Road Safety Audit

Project I.D. 6145-01-01
USH 12 (Wisconsin Dells Parkway)
Broadway Street to Whitlock Street
Sauk County, WI

Prepared for:
WisDOT

EXHIBIT 2
CORRIDOR CRASH RATES
US 12 ROAD SAFETY AUDIT
PROJECT ID 6145-01-32
SAUK COUNTY, WISCONSIN

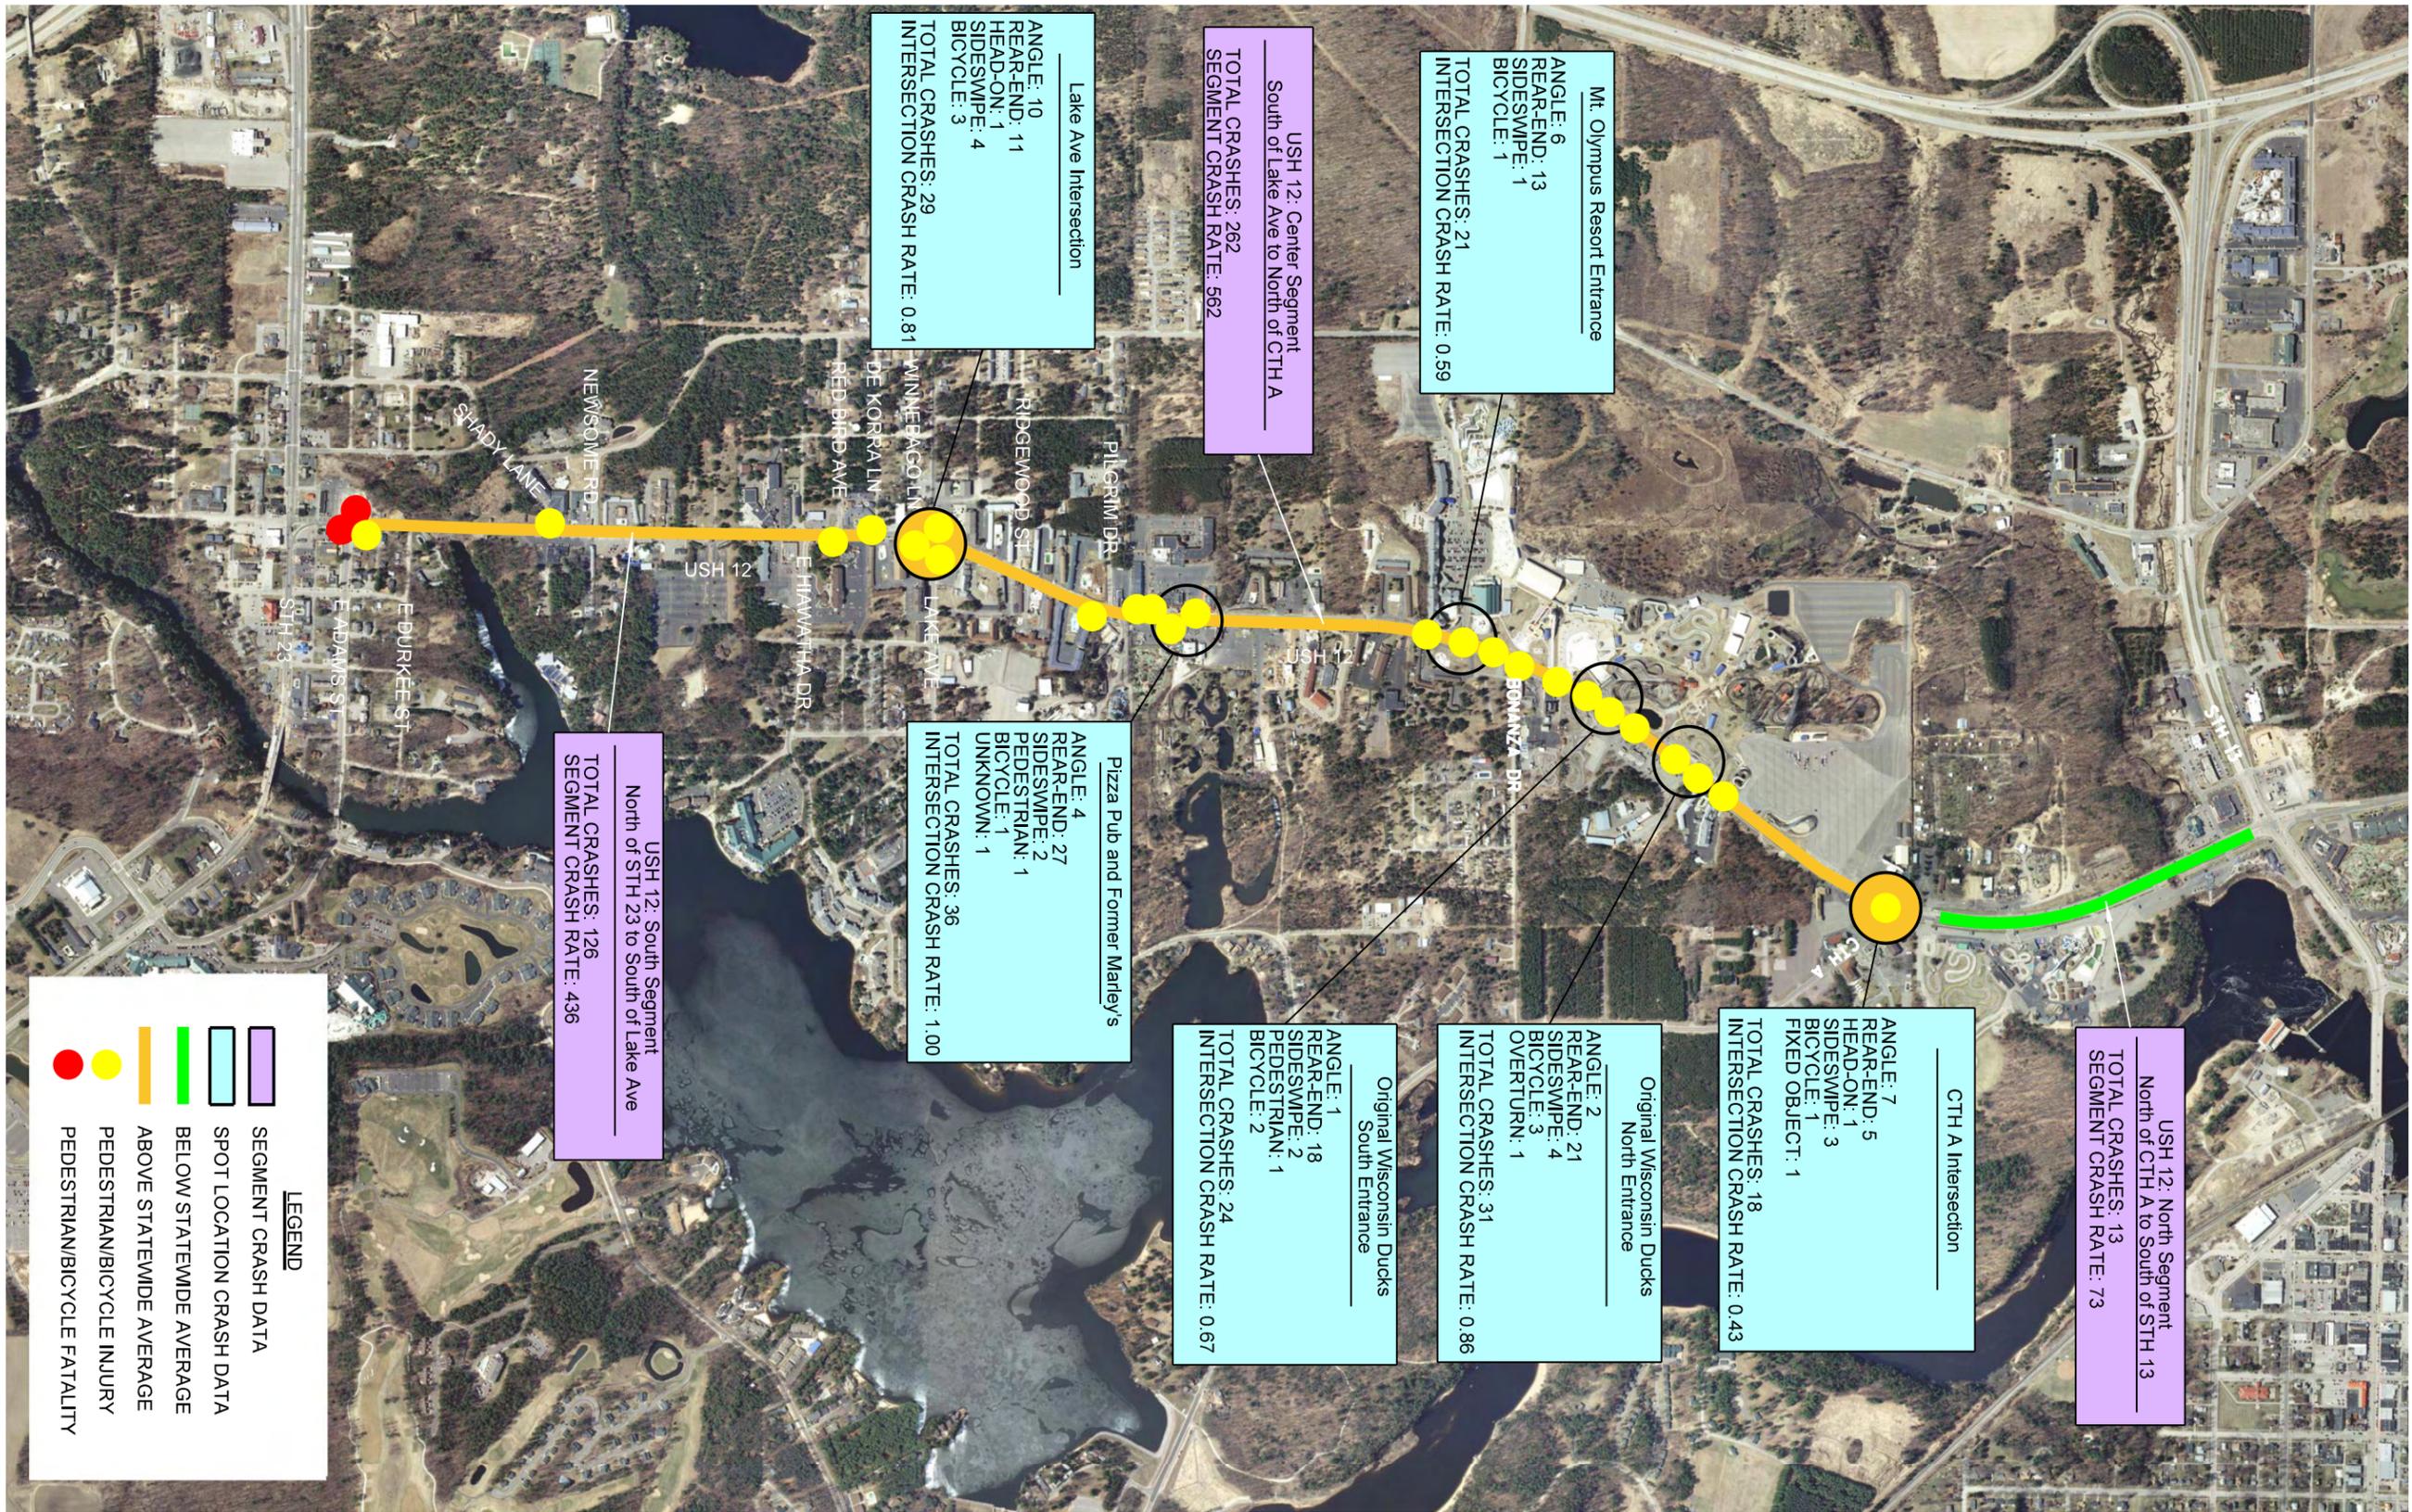
For comparison purposes, crash rates for roadway segments are calculated in units of crashes per 100 million vehicle miles (HMVM). Table 1 summarizes the crash rate for the three roadway segments included in the study area. The roadway crash rates are also illustrated on Exhibit 2.
